CERTIFICATE OF APPROPRIATENESS

Applicant: Lawrence Lines, owner

Property: 1035 East 14th Street, lot 12, block 116, Norhill Subdivision. The property includes a historic 1,557 square foot, one-story wood frame single-family residence and a detached garage situated on a 5,000 square foot (50' x 100') interior lot.

Proposal: Alteration – Porch

SITE PLAN

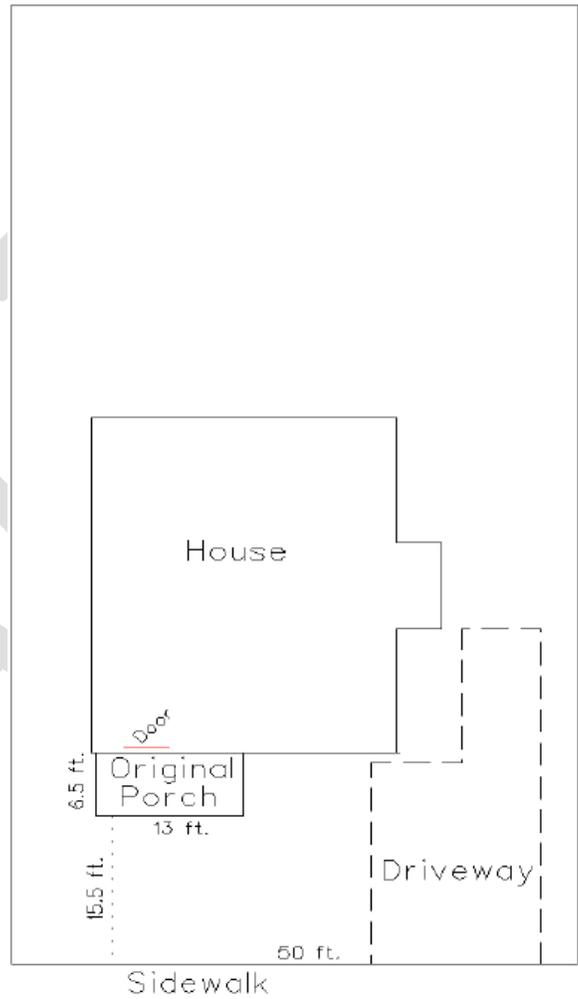
Shape/Mass: Existing porch measures 6' 6" deep by 26' 10" wide. The 13' wide west section features a gabled canopy and smooth texture brick matching the brick on the rest of the original structure. The east 13' 10" section is a later addition with no canopy and brick with vertical scoring.

The applicant proposes to remove the non-original section of the porch. Sections of original brick that were removed in order to incorporate the porch addition to the original structure will be replaced with matching smooth texture brick. This material was used in the porch addition and will be re-installed onto the original structure.
